STRUCTURAL TAC - Building

FBC TRACKING CHART: PROPOSED MODIFICATIONS 2006 Annual Interim Code Amendments to the 2004 Florida Building Code

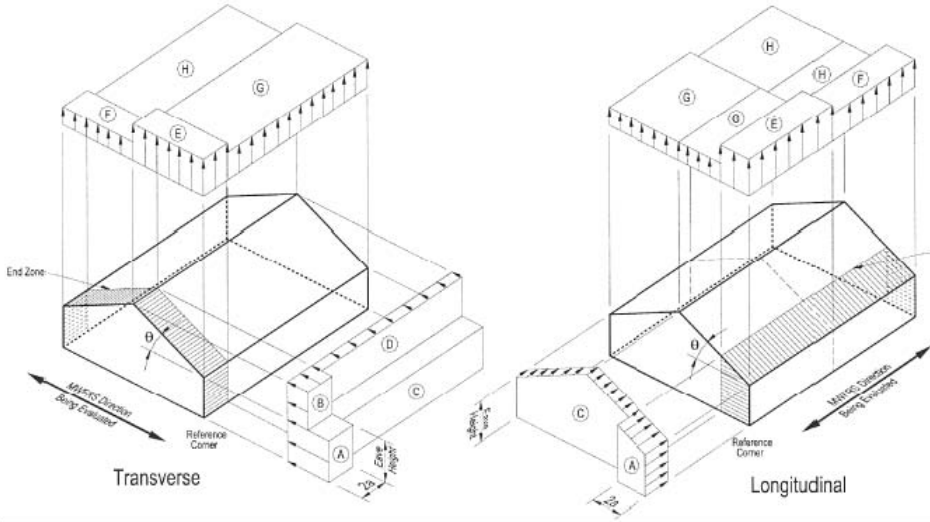
<p>1609.3 Basic wind speed. The basic wind speed in miles per hour, for the development of windloads, shall be determined from Figure 1609. Basic wind speed for the special wind regions indicated, near mountainous terrain and near gorges shall be in accordance with local jurisdiction requirements. The exact location of wind speed lines shall be established by local ordinance using recognized physical landmarks such as major roads, canals, rivers and lake shores whenever possible.</p>	[Mod 1922] None of the special wind regions exist in Florida nor are they shown on the map.	Deletes “special wind regions” reference in text
<p>FIGURE 1609.6A APPLICATION OF MAIN WIND FORCE RESISTING SYSTEM LOADS FOR SIMPLE DIAPHRAGM BUILDS</p>	[Mod 1729] Will provide clarity and consistency with ASCE 7-02	Editorial change by staff

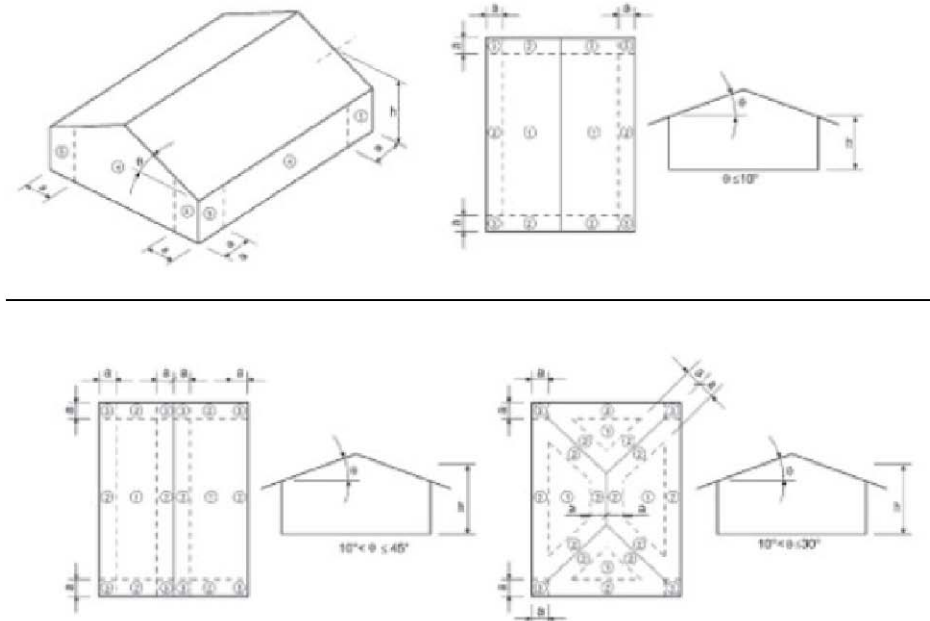
Section/ Chapter	Rationale	Summary
<p data-bbox="210 373 1134 844"></p> <p data-bbox="191 933 546 966">Add the following Figure:</p> <p data-bbox="388 998 955 1063"><u>FIGURE 1609.6.2.1</u> <u>MAIN WIND FORCE LOADING DIAGRAM</u></p>
